PLAN REVIEW COMMENTS FOR DP-01-25-019535

Plan Type: Development Plan **Apply Date:** 01/13/2025
Plan Status: Active **Plan Address:**
Case Manager: Dan Frazier **Plan PIN #:** R610 039 00A 0385 0000
Plan Description: A request by Randolph Stewart , on behalf of Olympia Rymko for approval of a Preliminary Development Plan application. The project consists of lots, each with one mixed use building and one carriage house with associated infrastructure. The property is zoned Neighborhood Center - Historic District and consists of approximately 0.29 acres identified by tax map numbers R610 039 00A 0254 0000 and R610 039 00A 0385 0000 located on the northeast corner of Boundary Street and Green Street.
STATUS: This item will be heard at the February 12, 2025 Development Review Committee meeting.

OLYMPIA RYMKO
LOT 1A-1B GREEN STREET
BLUFFTON, SC
SITE PLAN

SHEET No.
LS101
OF

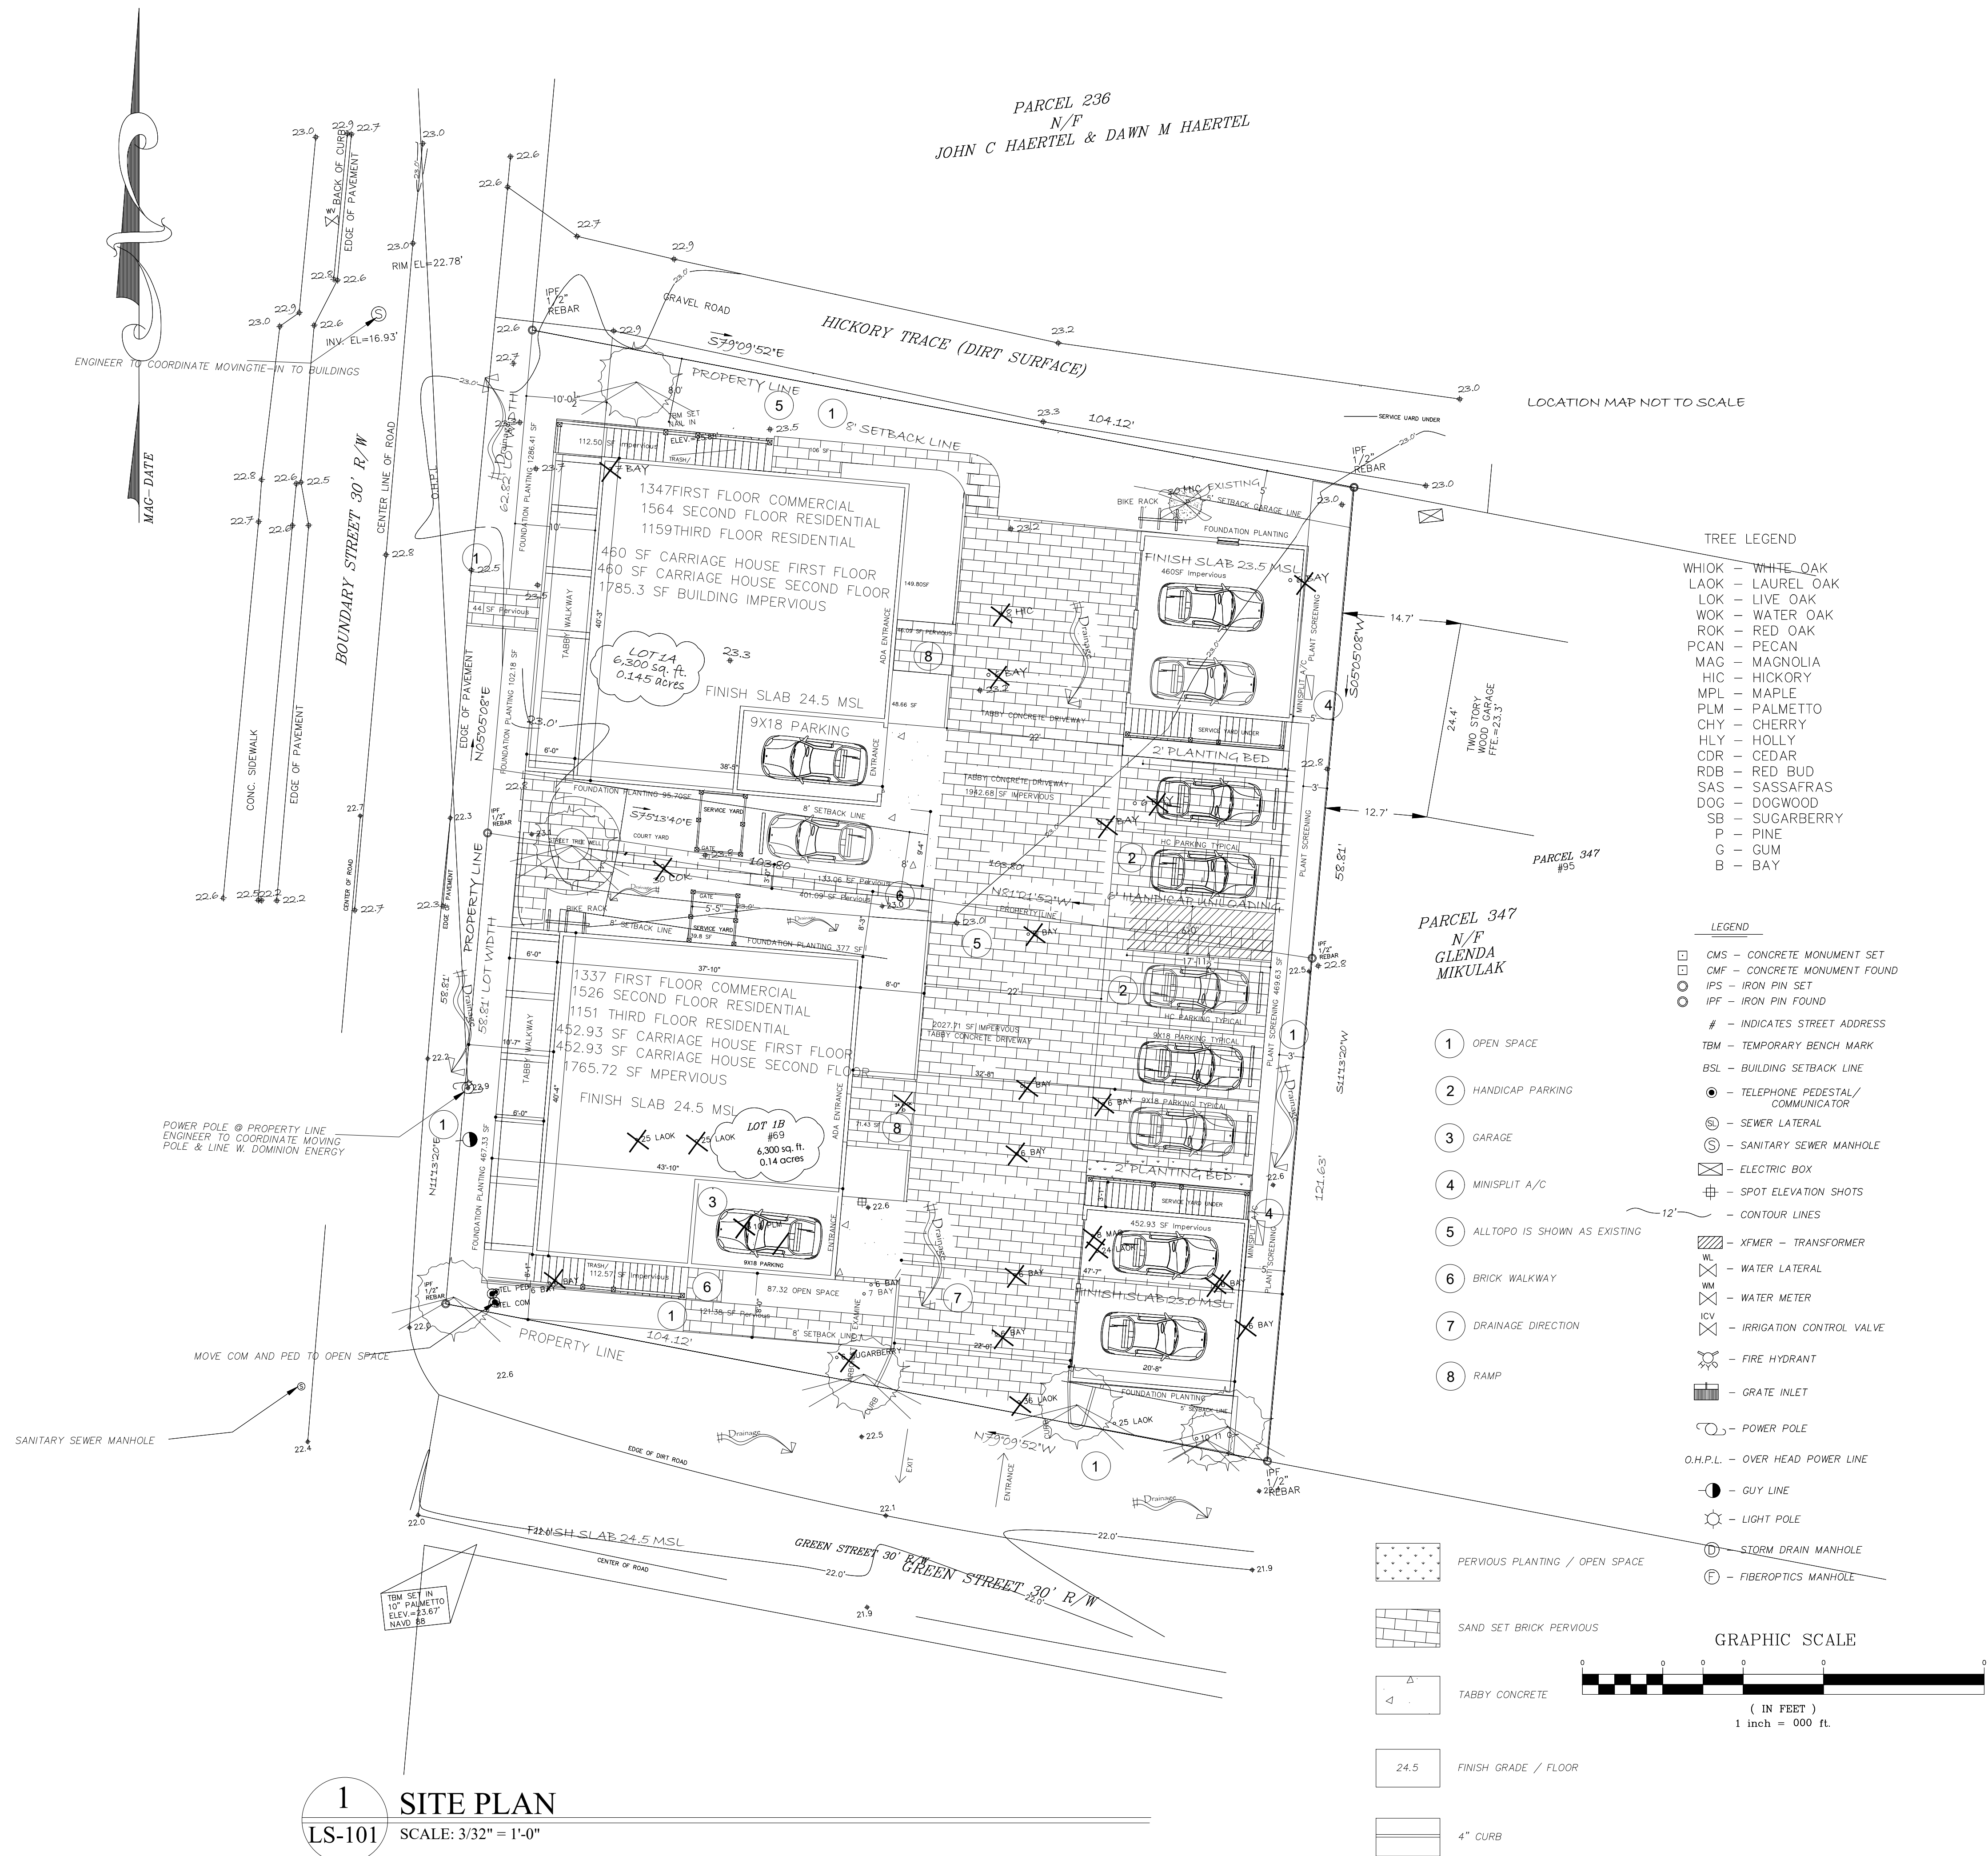
1. Landscape plan does not reflect access to trash enclosure underneath stairs.
2. The plans are not sealed and signed by a registered engineer or landscape architect licensed to practice in South Carolina.

3. Provide an automobile turn analysis demonstrating ability for vehicular movement in the parking lot.
4. Clarify the edge of pavement adjacent to Green Street. The proposed plan shows the edge of pavement ends before reaching Green Street.

8. Clarify location of the dumpster, if applicable.
9. Demonstrate that open space is true open space, not drainage. 10% functional, 20% overall.
10. The site plan shows the removal of nearly every tree. Demonstrate that during site planning, consideration was given to the existing tree canopy and every reasonable effort was made to maximize the preservation of the existing canopy (UDO 5.3.3.C).

11. the access easement shown on the survey needs to be shown on the site plan
12. Additional comments may be provided at time of Development Review Committee meeting.

2. There is conflicting paving information in site plan and project narrative. On the site plans, the drive isles, walkways, and parking spaces are shown as pervious pavers per the legend. However, the text notes within those areas states tabby concrete driveway. The narrative states impervious tabby concrete. Clarify and revise.
